TECHedition

Topic : NEW JPC MODEL WITH WATER PRESSURE SWITCH
TEC edition No : TEC/E/005/2012
Date issued : 13/09/2012
DESCRIPTION : JPC MODEL ADD THE WATER PRESSURE SWITCH

New Type JPC WITH THE WATER PRESSURE SWITCH

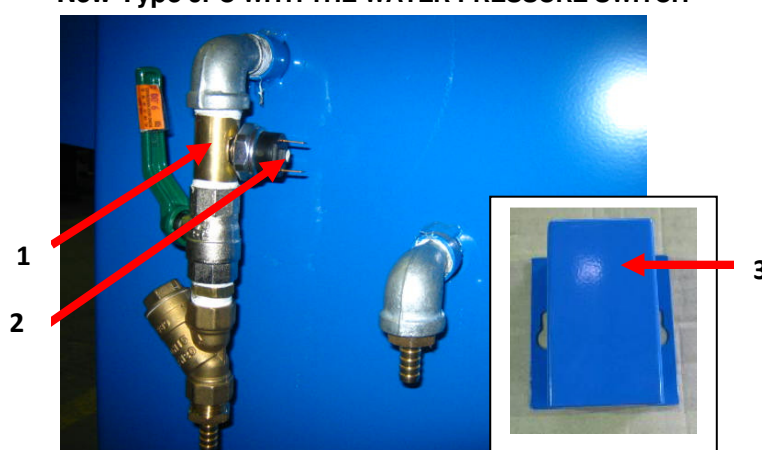
NEW PART ADD FOR THE JPC MODEL

Prevent from the overload (Warning Light will "ON")
This is cause by the user not "ON" the Water Cooler
